H. B. ROBINSON STEAM ELECTRIC PLANT, UNIT NO. 2  
DOCKET NO. 50-261/RENEWED LICENSE NO. DPR-23

**FIRST SIX-MONTH STATUS REPORT IN RESPONSE TO MARCH 12, 2012, COMMISSION ORDER  
MODIFYING LICENSES WITH REGARD TO REQUIREMENTS FOR MITIGATION STRATEGIES FOR  
BEYOND-DESIGN-BASIS EXTERNAL EVENTS (ORDER NUMBER EA-12-049)**

**FIRST SIX MONTH STATUS REPORT (ORDER EA-12-049)  
 H.B. ROBINSON STEAM ELECTRIC PLANT (RNP), UNIT 2**

Figure 3, FLEX Connection Locations – Mechanical – Core Cooling – SG Makeup (Open Item 71)

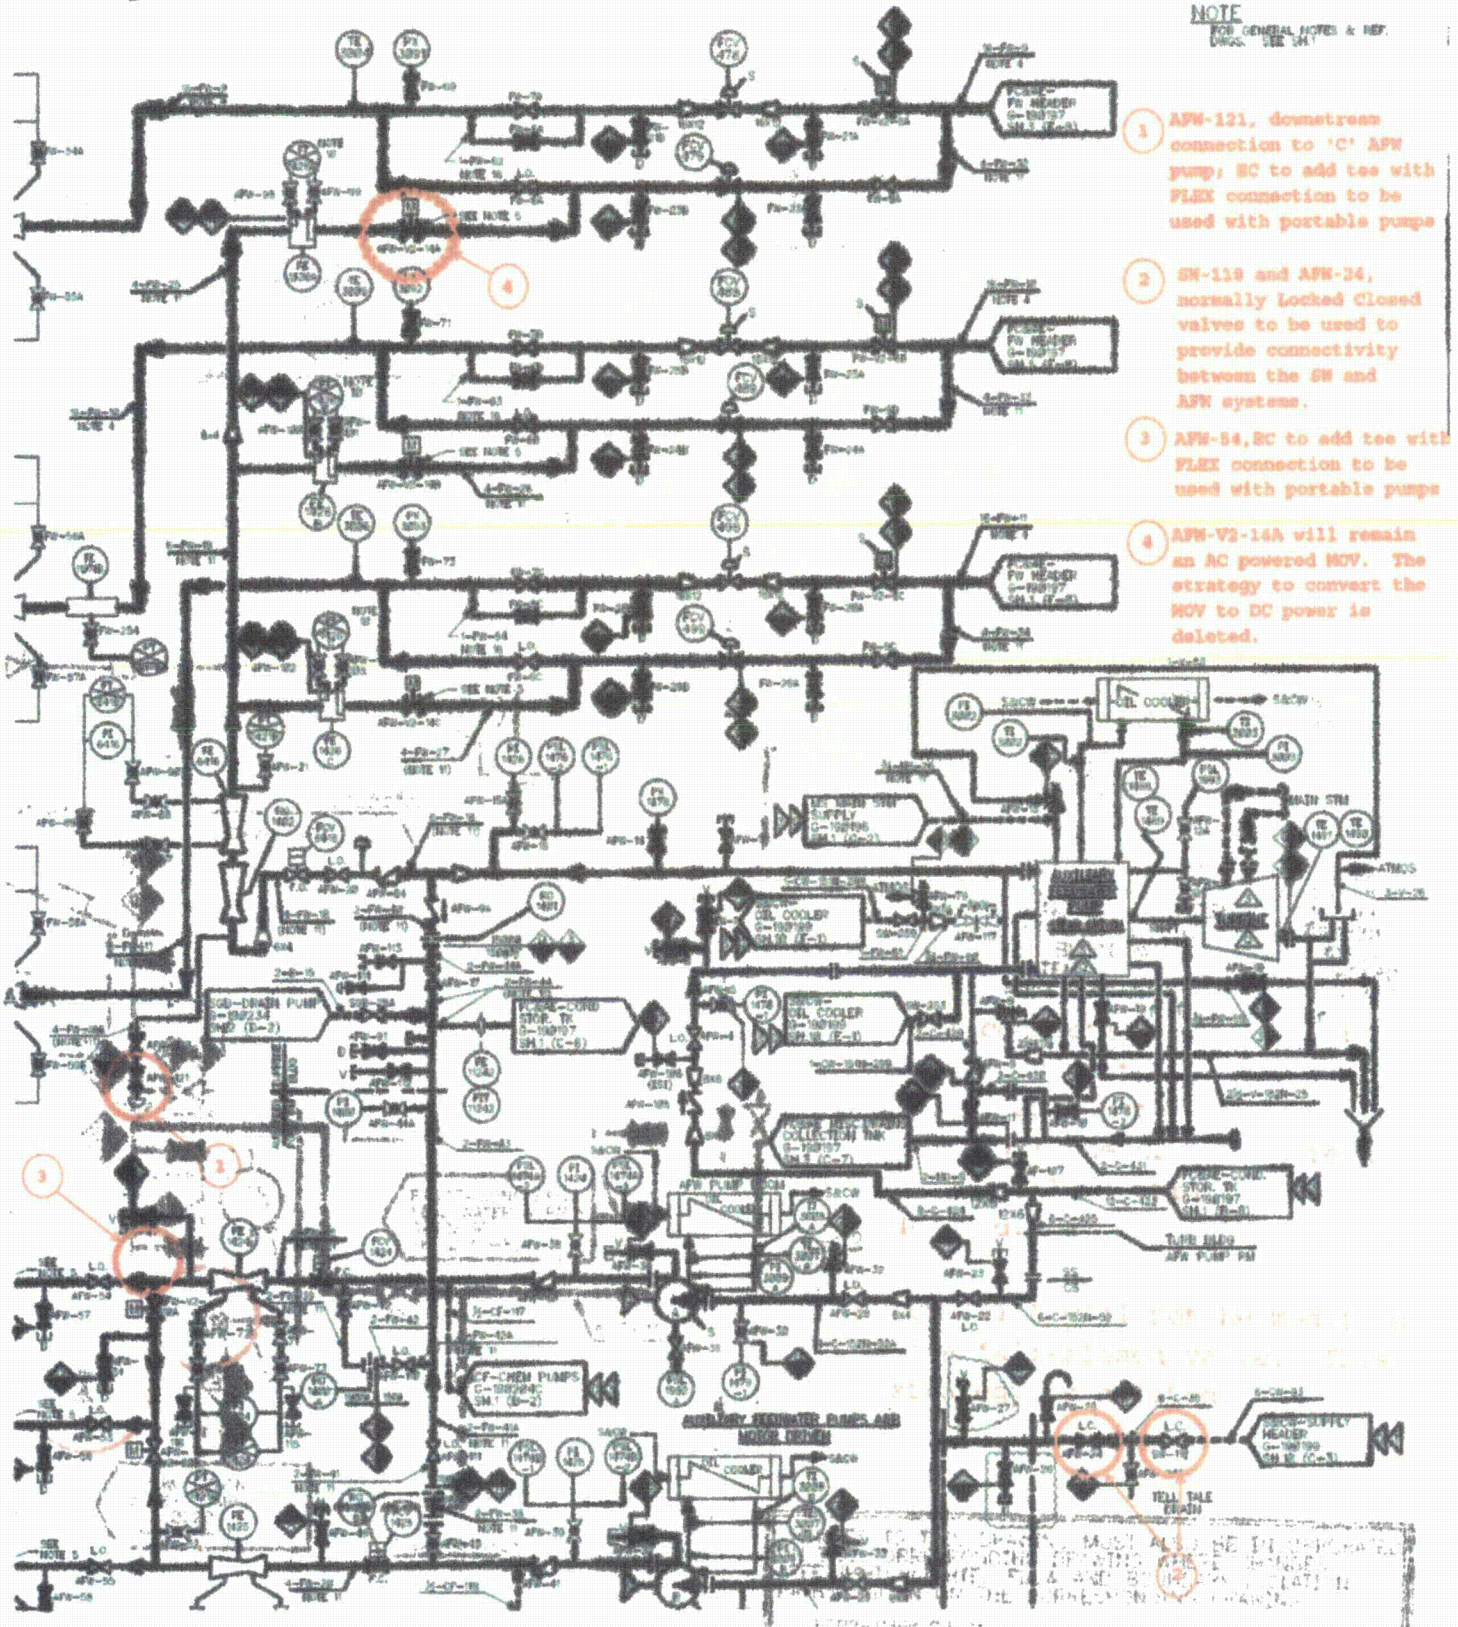
In lieu of installing a Direct Current Powered Motor Operated Valve (DC MOV) on one steam supply to the Steam Driven Auxiliary Feedwater Pump (SDAFWP) and a DC MOV on one Auxiliary Feedwater (AFW) valve, the current emergency strategy of manually opening the valves will be retained. This is a proven time-critical action in RNP procedures (Ref. 4). Open Item 12 is deleted. Attachment 3, Figure 3 is revised.

- 1 AFW-121, downstream connection to 'C' AFW pump; EC to add tee with FLEX connection to be used with portable pumps
- 2 SW-118 and AFW-24, normally Locked Closed valves to be used to provide connectivity between the SW and AFW systems.
- 3 AFW-54, EC to add tee with FLEX connection to be used with portable pumps
- 4 AFW-V2-14A will remain an AC powered MOV. The strategy to convert the MOV to DC power is deleted.

Attachment 3  
 Figure 2, FLEX Connection Locations - Mechanical - Core Cooling - SG Makeup (Open Item 71)

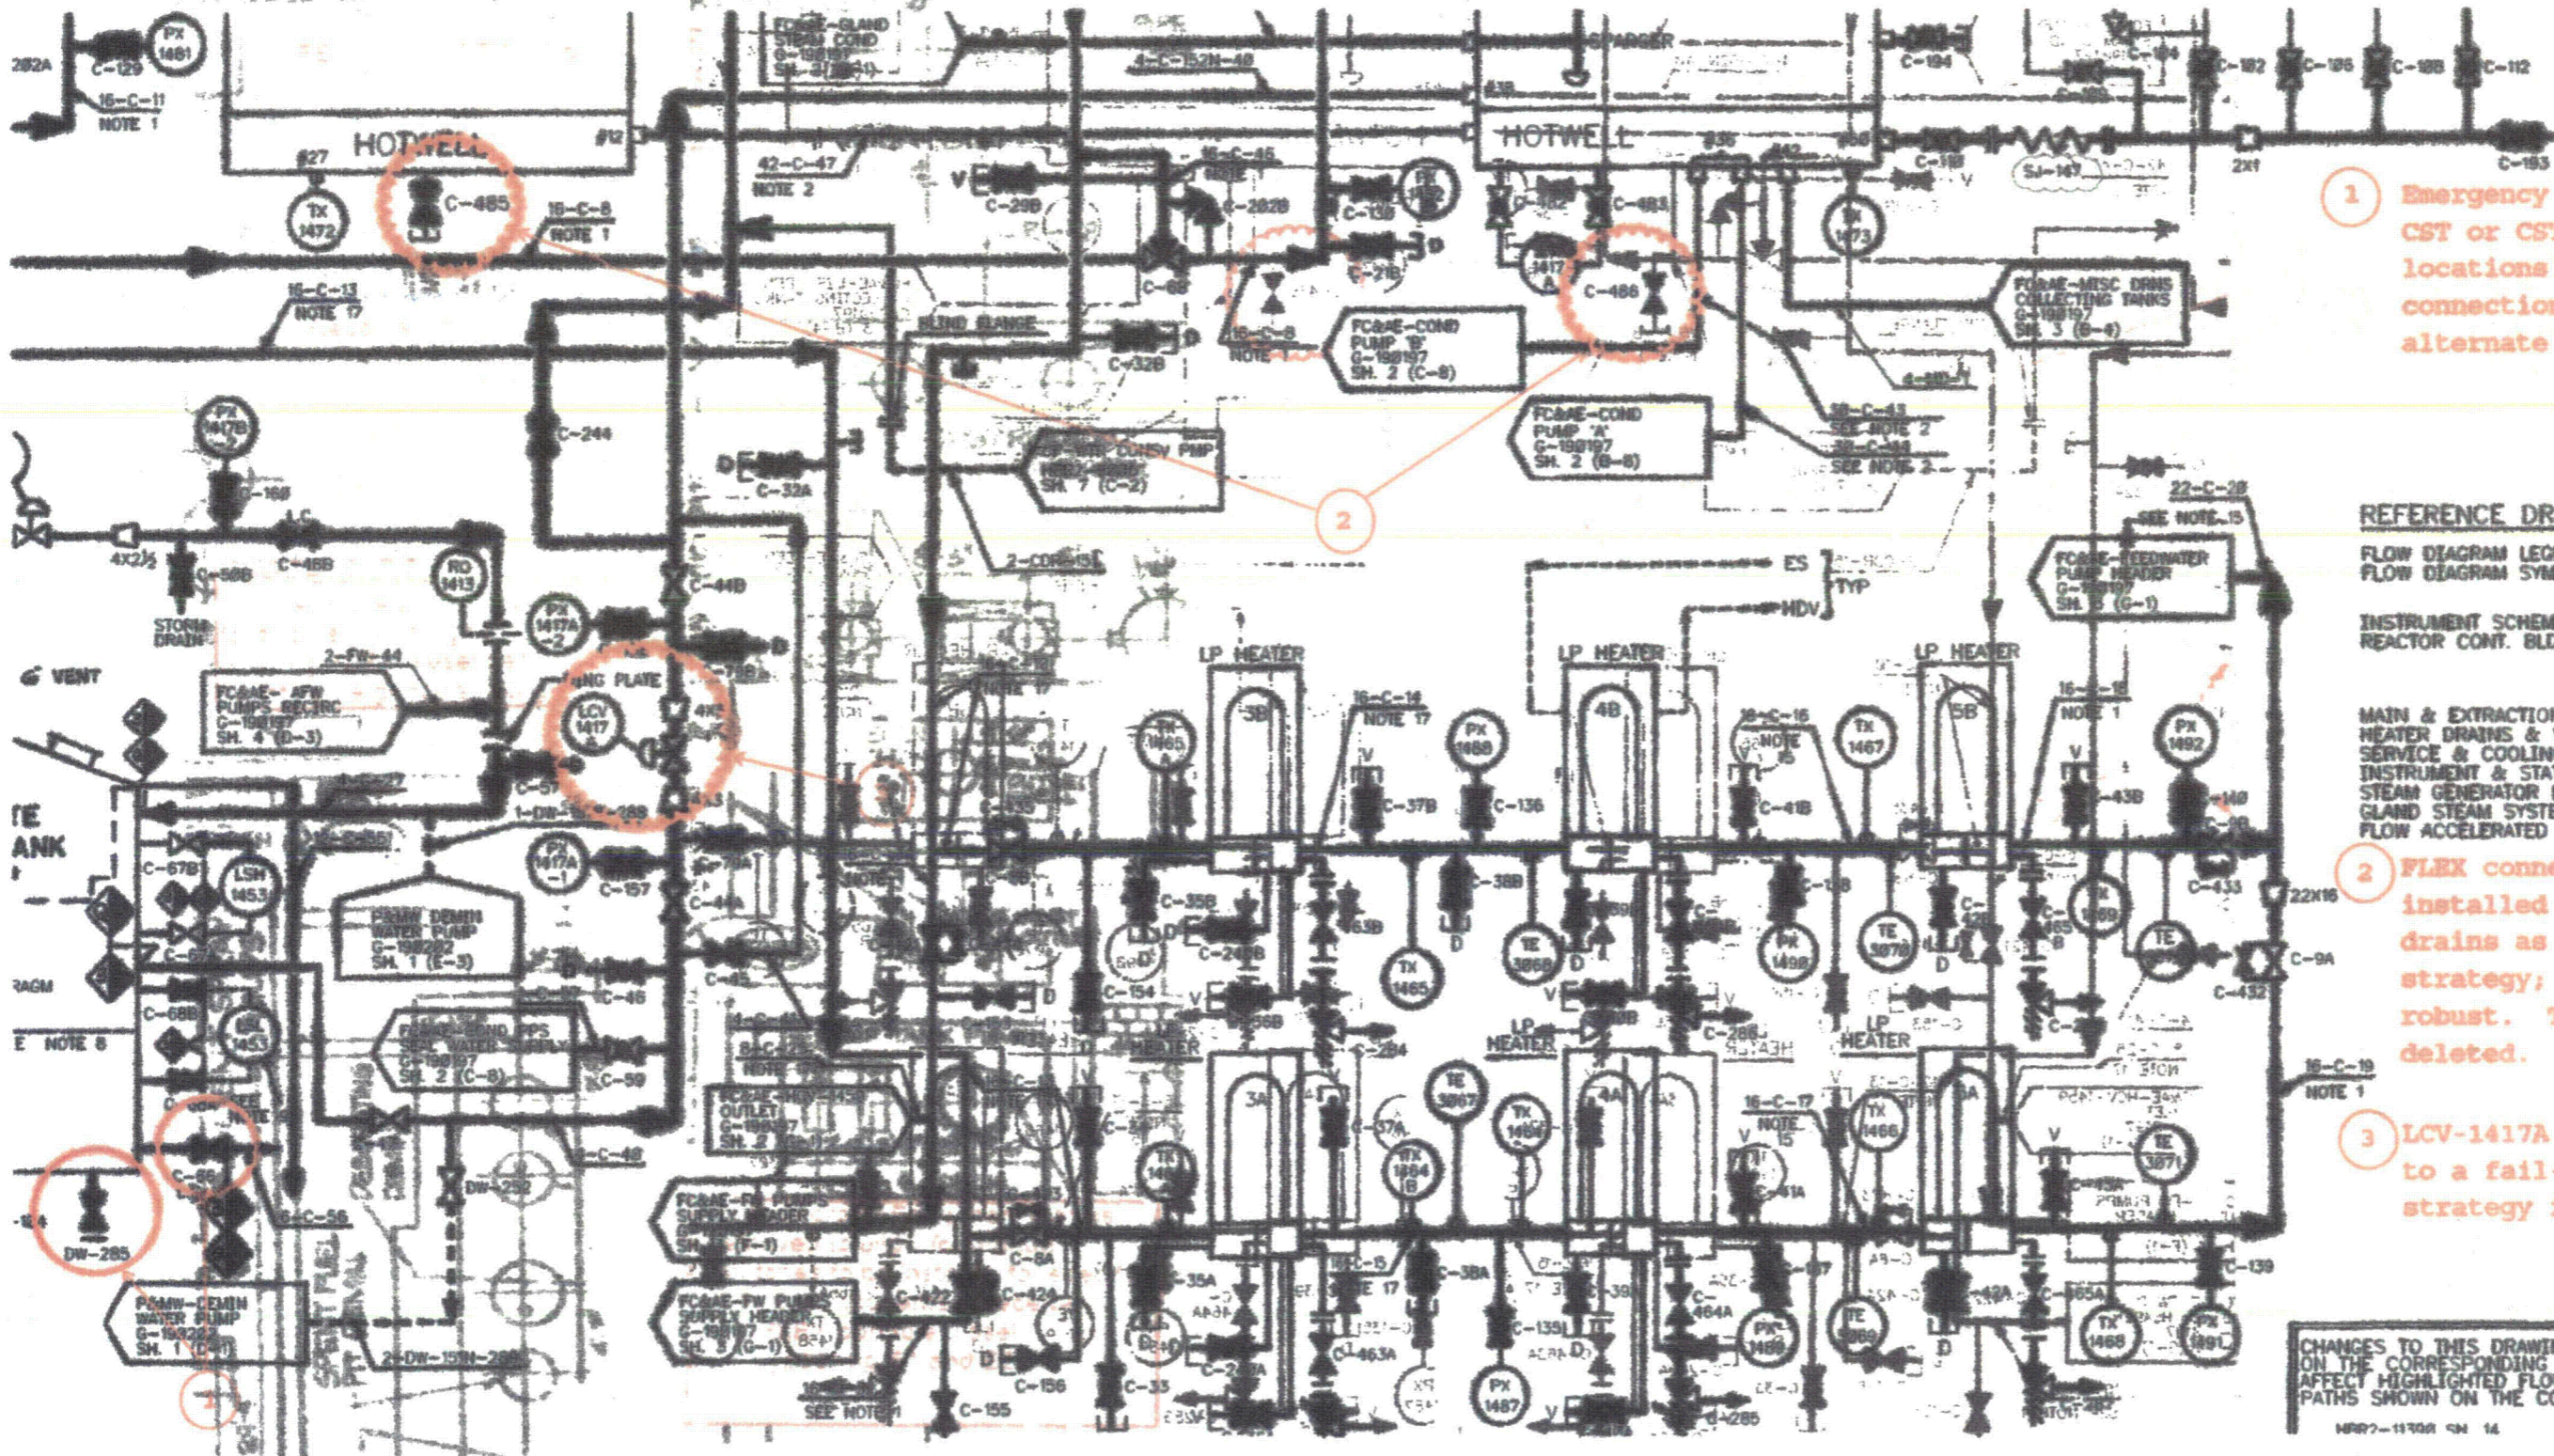
Upon further review and investigation, RNP discovered that a previous attempt to modify LCV-1417A occurred in 2010. RNP concluded that such a modification was not feasible. In addition, the potential loss of CST inventory is accounted for in the proposed Alternate CST's significantly larger volume of approximately 800,000 gallons. In lieu of modifying the hotwell makeup valve (LCV-1417A) from fail-open to fail-closed, the current strategy to manually isolate the valve will be retained (Ref. 4, Step 9). Open Item 15 is deleted. Attachment 3, Figure 2 is revised.

1 Emergency Fill Connection to CST or CST drain; viable locations for EC to add FLEX connection for makeup from alternate sources

2 FLEX connections will not be installed on the hotwell drains as a water source strategy; the hotwells are not robust. This strategy is deleted.

3 LCV-1417A will not be modified to a fail-closed valve. This strategy is deleted.
